Flight Procedures Cover Page	Task Action: FLIGHT CHECK	Task Type: IAP	Estimated Chart Date: 11/05/2020	APWS Task ID: D416A97A291F402298CBAFA8B5287CF9	APWS Project ID: 3D2A8C8DF5C842A1A478C0382D4F78A9
Procedure: RNAV (GPS) RWY 33 ORIG		Enroute: NO	Specialist: Cappabianco, Anthony		Agreement Number:
Airport ID: KDIK	Airport Name: DICKINSON - THEODORE ROOSEVELT RGNL		Airport City: DICKINSON		State: ND
Facility ID:	Facility Type:	Flight Inspection Remark Type: New FC Slot

FIPC BASIC FORM										
PROCEDURE: RNAV (GPS) RWY 33 ORIG			AIRPORT NAME: DICKINSON - THEODORE		AIRPORT ID: KDIK		SPECIAL CONTROL NO: BG-07-173-20			
FAC ID: KDIK33		CITY: DICKINSON			ST: ND		ORIG CHART DATE: 11/05/2020			
DFL TYPE: PROC/S	THIRD PARTY: <input type="checkbox"/> YES	EST. TIME ON SITE: 0.4	REIMB. NUMBER:		PTS TASK ID:					
PREFLIGHT NOTES										
REVIEWER:					DATE:					
COMMENTS:					CHECK ONE: <input type="checkbox"/> FLT CK REQ <input type="checkbox"/> NFCR <input type="checkbox"/> REJECT					
									YES	NO
					CPV COMPLETE?				X	
PROCEDURE RESULTS										
INSPECTION DATE: 09/22/2020		CREW #: VN407	N #: N89	INSTRUMENT PROCEDURE STATUS: <input checked="" type="checkbox"/> SAT <input type="che

AUTOMATED AL-120 RNAV (GPS) RWY 33

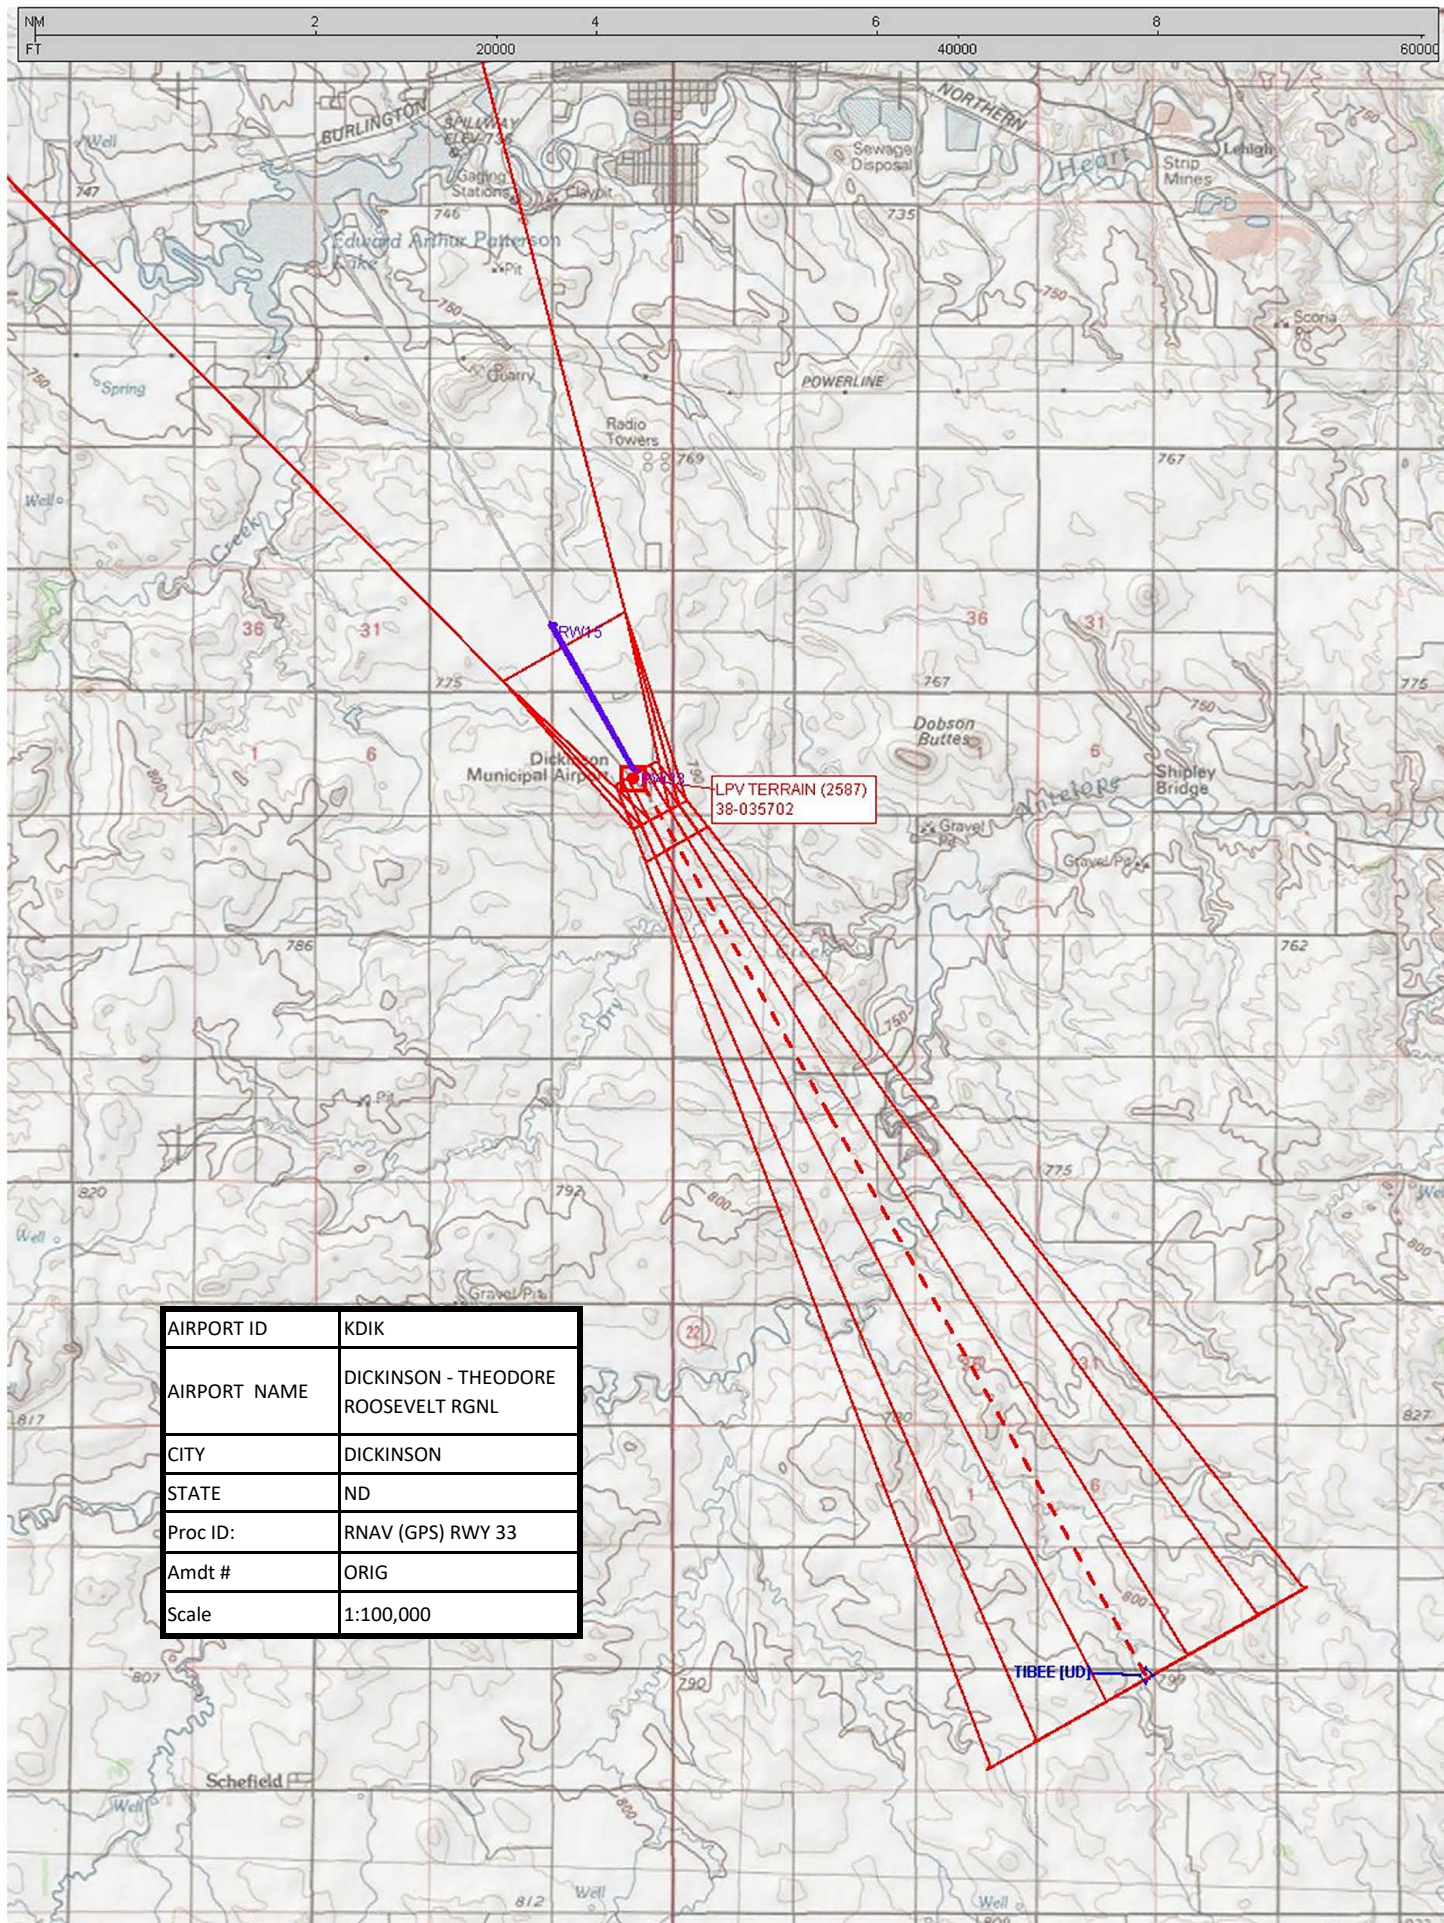
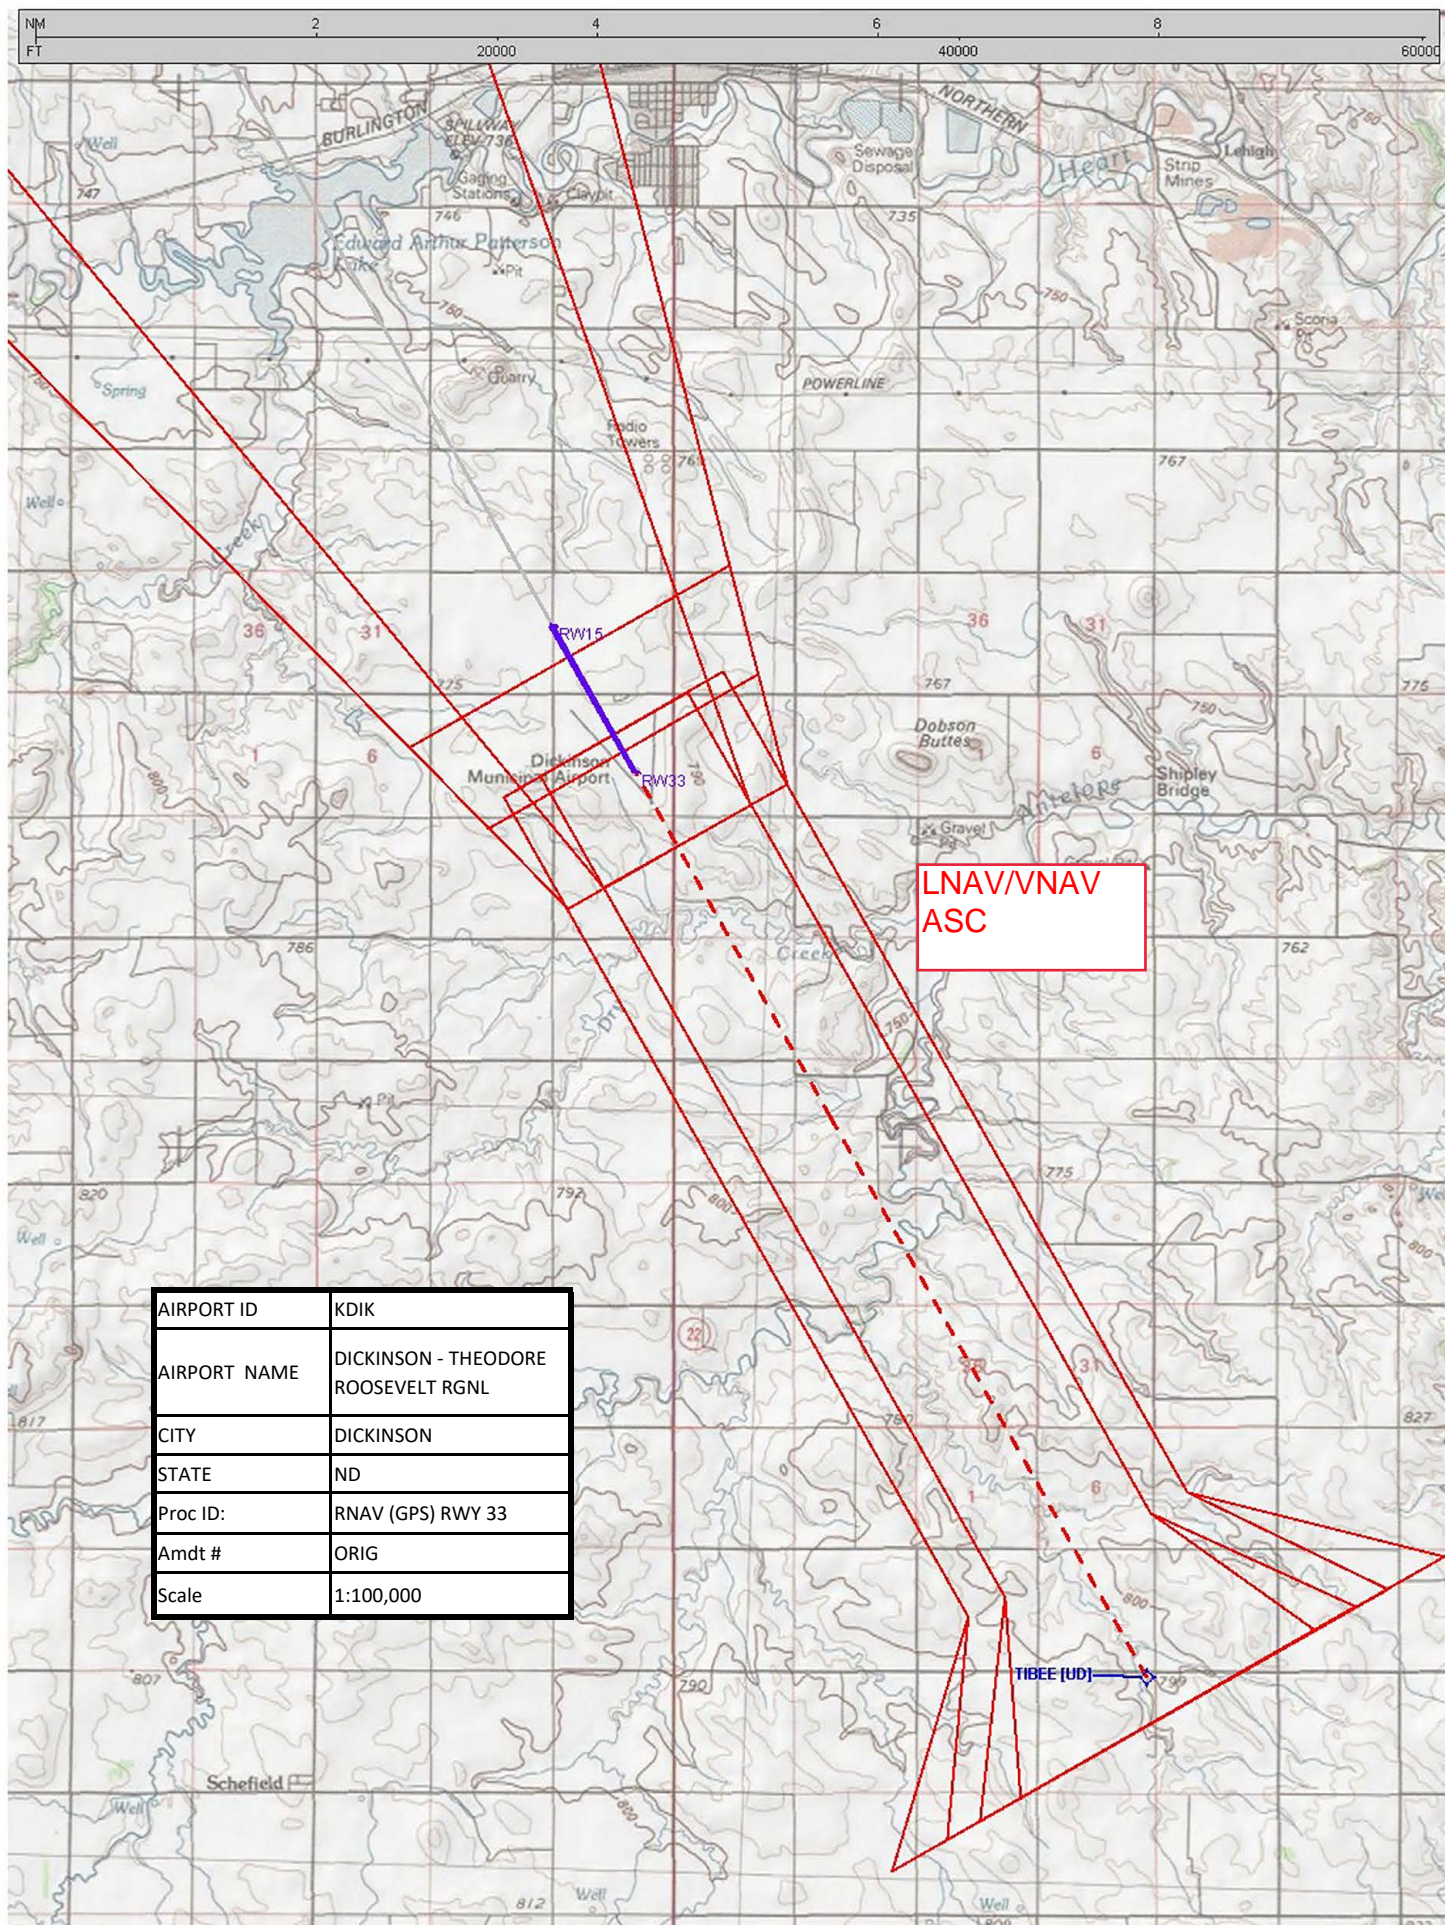
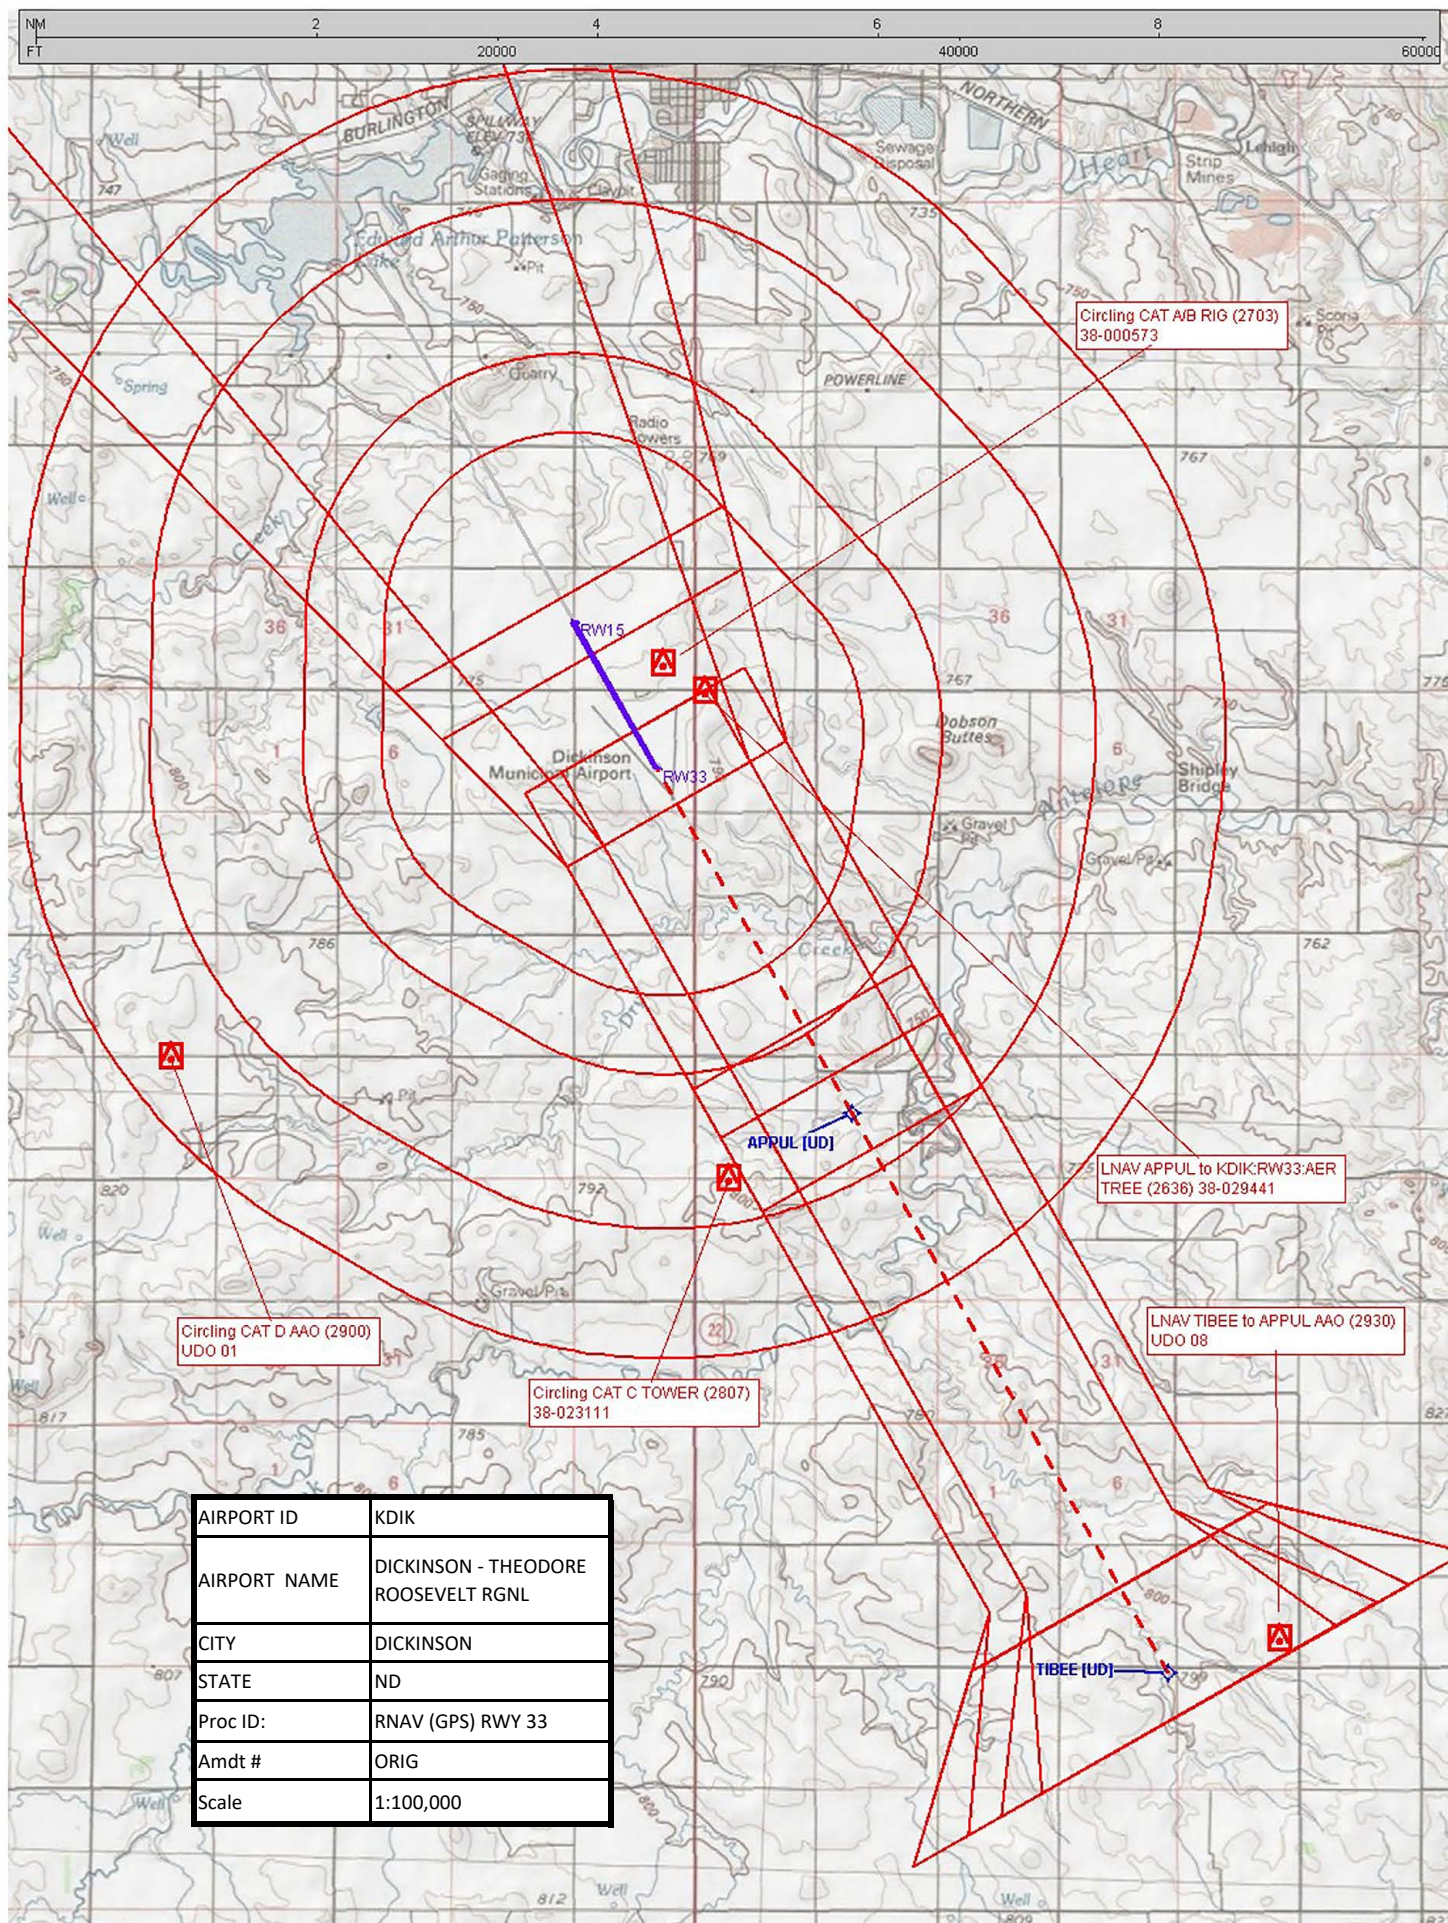
1. TERMINAL ROUTES – FINAL (LNAV) TO CHANGED FROM ‘APPUL’ TO ‘APPUL/2.83NM TO RW33.’

2. TERMINAL ROUTES – FINAL (LNAV) STEPDOWN FROM CHANGED FROM ‘APPUL’ TO ‘APPUL/2.83NM TO RW33.’

3. ADDED MINIMUM ALTITUDE ‘APPUL/2.83NM TO RW33 3540\*’ TO LINE 4 ON THE 8260-3.
